Southampton to London Pipeline Project

Site Specific Plan - QEP (tracked change)

Application Document: 8.57

Revision No. 3.0

Illustration 3.1: Sketch to show vegetation retention outside of work areas (Appendix B)

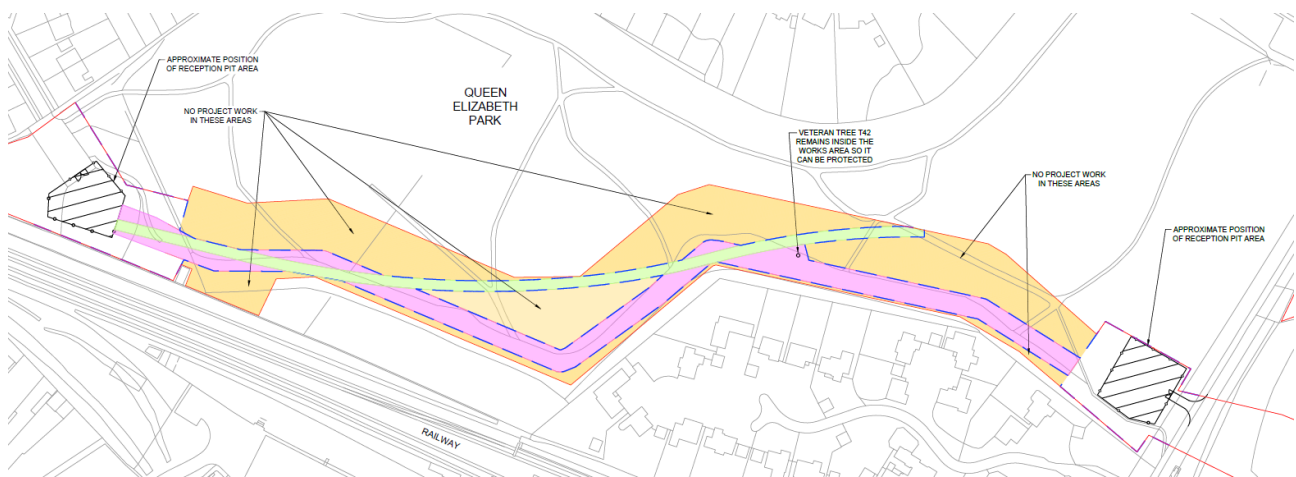
- 3.3.2 Based on the ~~current intended~~ pipe alignment, ~~a small number shown at Appendix B of trees will be removed, approximately this document,~~ 30 non-mature trees, ~~will be removed (as listed in Appendix C),~~ largely adjacent to the cycle/pedestrian path. These are trees of a lower arboricultural value and are in areas previously discussed with Rushmoor Borough Council as benefitting from some tree removal, ~~if.~~ If not identified for removal, then the remaining identified trees will be retained, unless the relevant planning authority (Rushmoor Borough Council) agreed otherwise in accordance with Requirement 17 of the draft DCO. The installation will not require the removal of any mature or veteran trees. Vegetation will only be removed within the 5m and 10m working areas, the construction compound and the two reception pit areas as identified in illustration 3.1 below. Areas outside of this will not be removed by the works unless agreed with the relevant planning authority.
